Letter of Response

**RE: 35-41 Wilfred Barrett Dr, THE ENTRANCE NORTH NSW 2261
Development Application DA/308/2011**

We refer to the comments from the JRPP meeting dated 17 May 2012. We have since tested a few design options in response to issues raised by the JRPP and we have had a meeting with Wyong Council on 20th June 2012 to discuss the best design outcome. This letter accompanies the revised architectural plans Issue E.

Northwest Lake Elevation
test option - no fill below RL 1.8

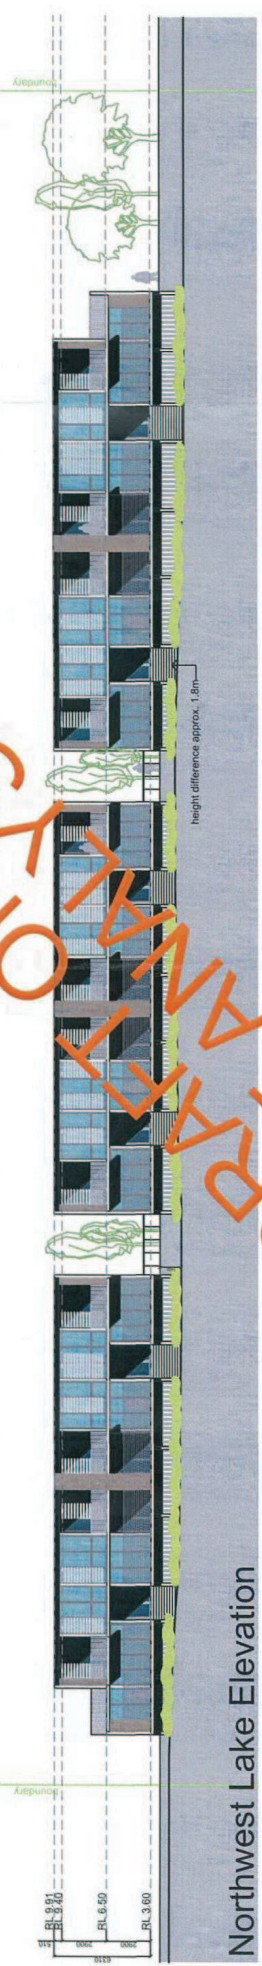
In response to Mr Grant's comments, we have tested the option of removing the fill along the lake side:

Removal of fill will result in a significant level difference between the living spaces of the lakefront units and their courtyards (approximately 1.8m). The living space will be disconnected from its private outdoor space. Such design proposal will not only be of poor amenity for future residents living in those lakefront units, it will also have a very negative impact on the economic value of these units. (refer appendix 1)

Moreover, the lakefront common area will not be easily accessible for people in wheelchairs due to the level difference. The ease of access from ground level to the common open space along the lake will be greatly affected. The common open space will become disconnected with the rest of the development, and not likely to be frequent by residents. The valuable lake front area will eventually become a non active space.

Based on our design analysis, the engineer's expert opinion and our meeting with council, we strongly believe that the benefits of having fill in the development prevails. Therefore, we have maintained our initial proposal of having fill along the lakefront area to enhance living amenity to future residents. This will not only maintain the direct relationship between the living areas and the private open space, it will also encourage regular use of the common open space and will improve passive surveillance along the site.
